# Rapid Update 821 Grecale License Plate Holder Replacement

DATE: June 4 2026

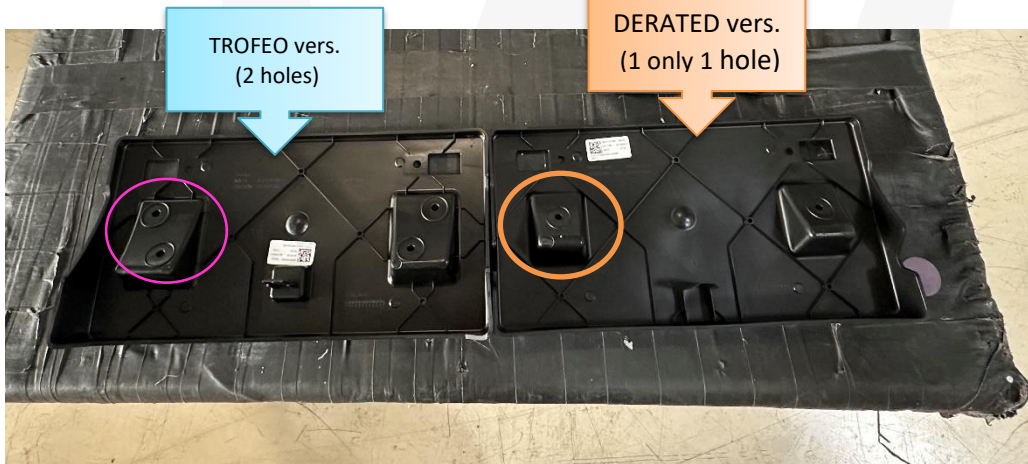
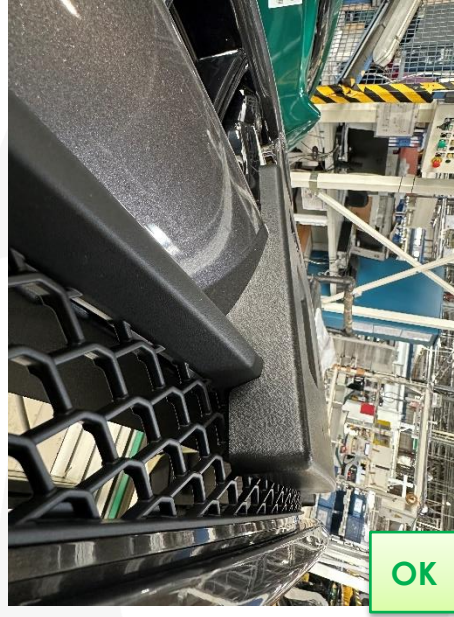
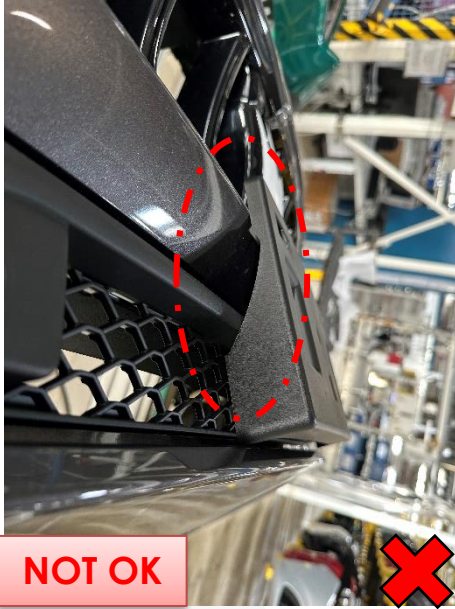
Certain Maserati vehicles listed in **MODISCS+** have an incorrect front license plate bracket installed from production.

- The bracket does **not match the shape of the front bumper**
- This makes it **impossible to install the license plate**

**Trofeo Version:** 2 mounting holes

**Derated Version:** 1 mounting hole (correct part for this update)

1. Always check ModisCS+ to see if the vehicle is involved in this action and if it has not been previously performed.
2. Remove the front license plate holder from the kit located in the rear trunk and install the correct "**Derated**" version (P/N 670179485) so it properly aligns with the front bumper.
